Subject: Tennessee Valley Authority (TVA) tailings disposal
facility near Edgemont, South Dakota

Task Order No. 003 Contract No. NRC RG4-83-673

Licensing Assistance/Geotechnical and Hydrological
Evaluations/URFO;
Review of Settlement Measurement Proposal

FIGURE

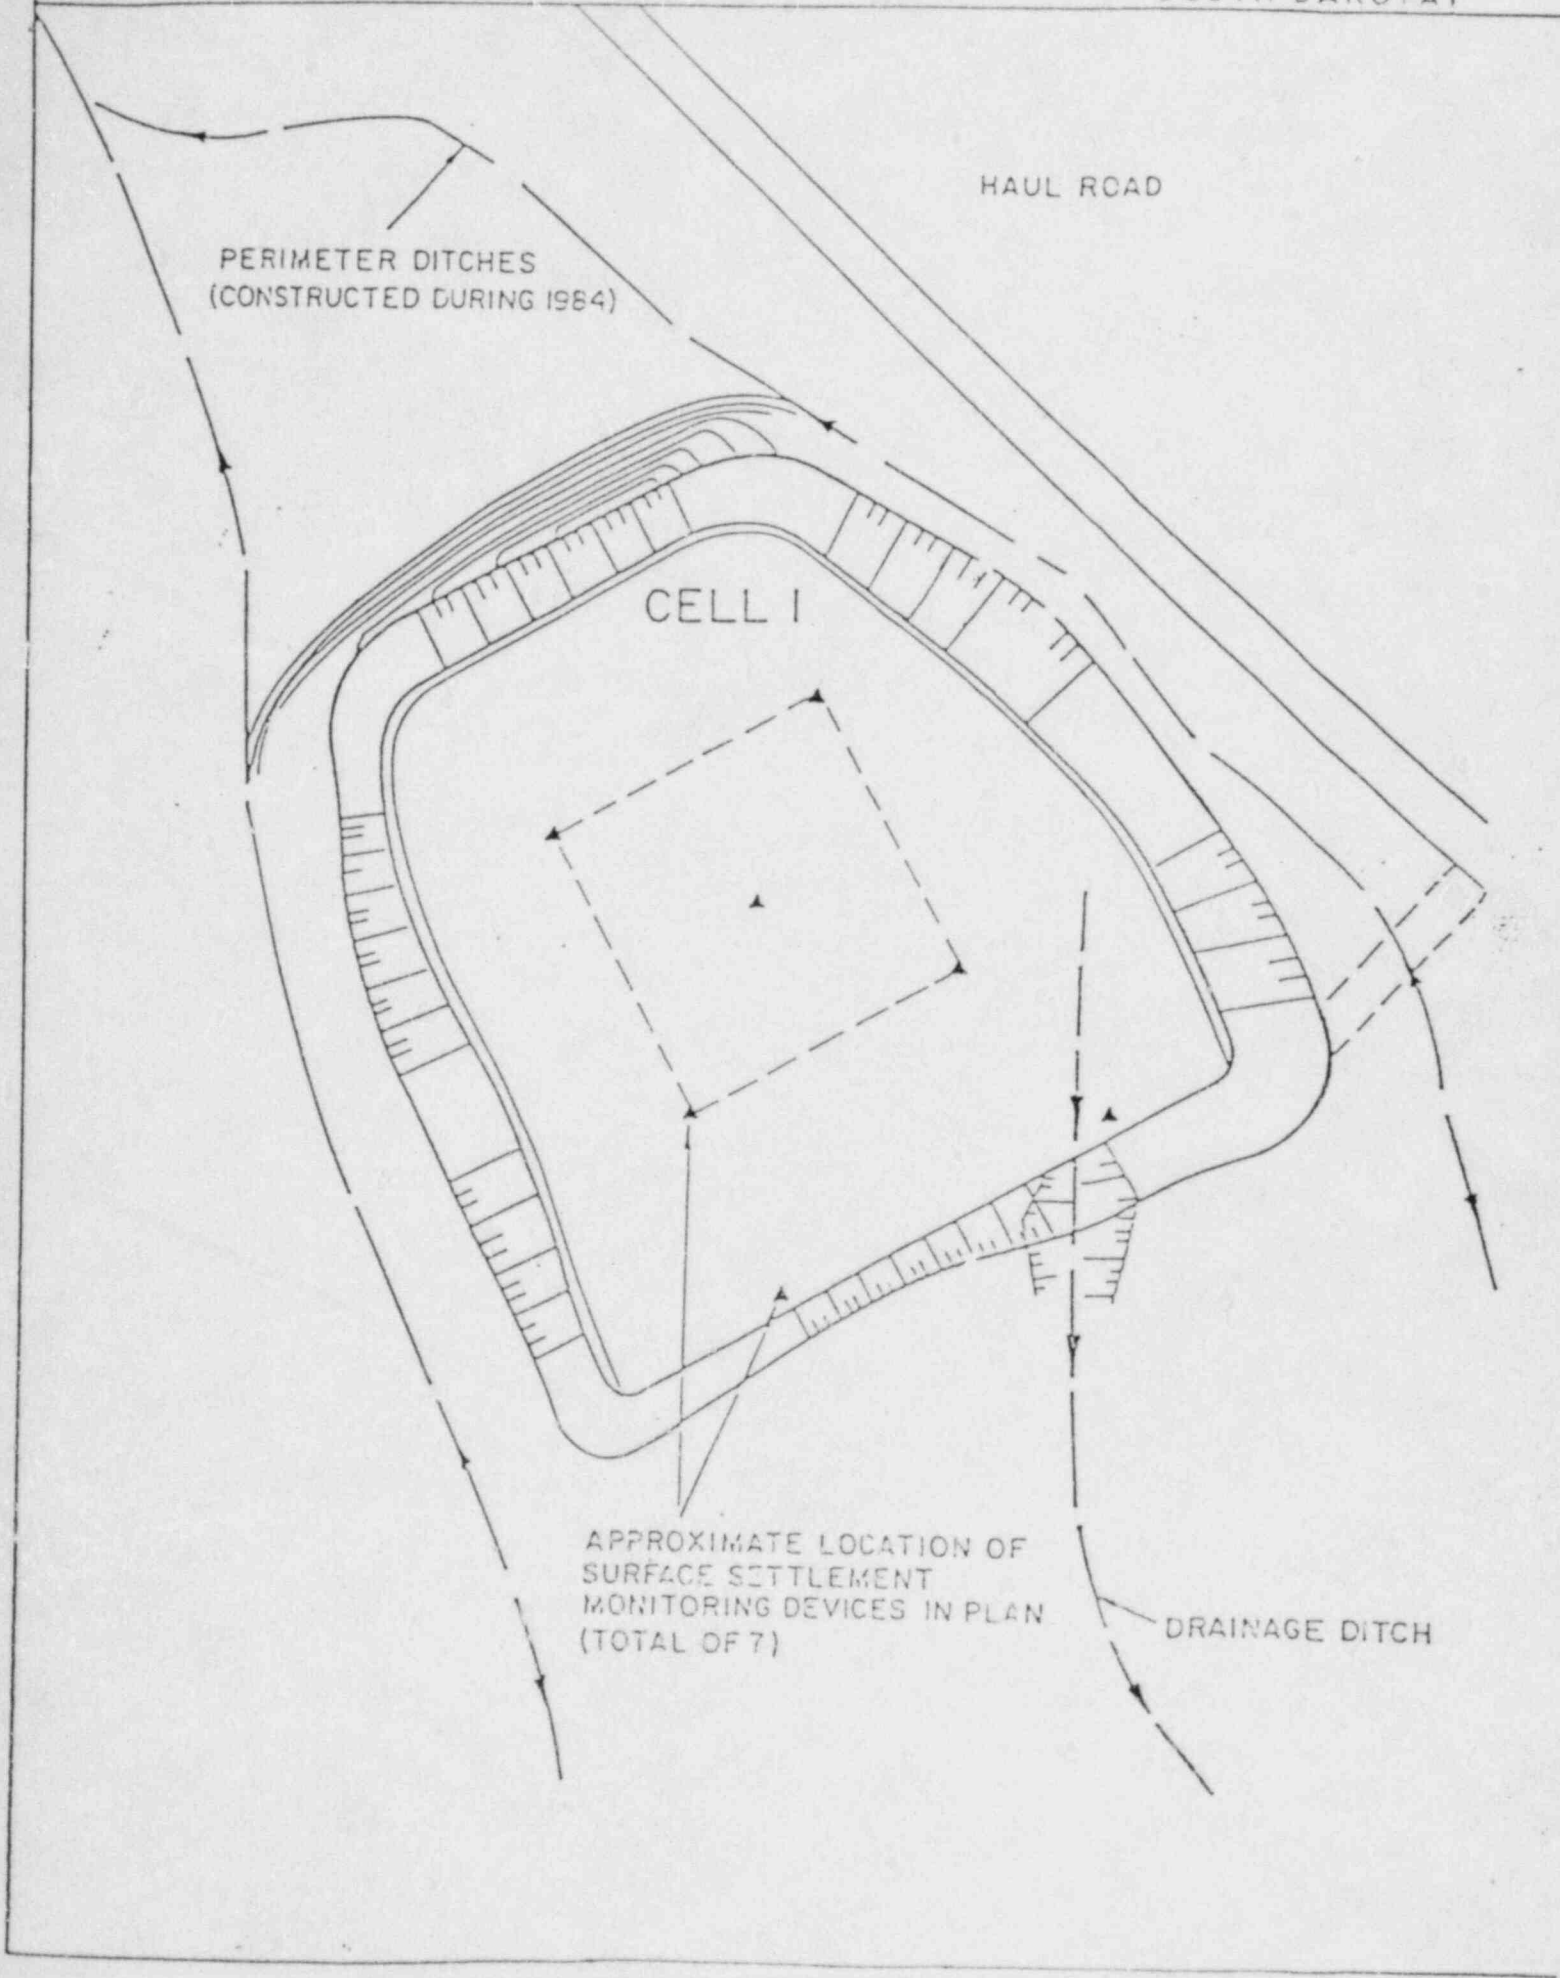
1. Seven settlement points, installed at approximately the locations shown on Figures 1 and 2, should be an adequate number for Cell 1.
2. Frost action after prolonged cold temperatures could extend below 4 feet in depth.
3. The monitoring frequency (biweekly, reduced to a less frequent basis as settlement stabilizes) is considered adequate.
4. A plywood base plate (Figure 3), suggested as an alternate to a metal base plate, could warp when exposed to moisture and thereby give erroneous settlement readings.
5. No plan was shown for the location and establishment of a stable survey point from which settlement readings can be made.

1. The need for settlement points on the remaining cells should be determined after readings from Cell 1 settlement points have stabilized and the data have been plotted and reviewed.
2. An accurate record should be made of the type and location of the mill debris placed into Cell 1.
3. The settlement point base plate should be buried a minimum of 5 feet below surface to avoid frost action on the plate.
4. All base plates should be made of metal; plywood is considered unsatisfactory.
5. To facilitate removal of the settlement point rod, consideration should be given to the use of non-corrosive metal when fabricating the settlement points.
6. A stable survey point from which settlement readings can be made should be established outside Cell 1, and in a location not subject to disturbance by construction equipment.
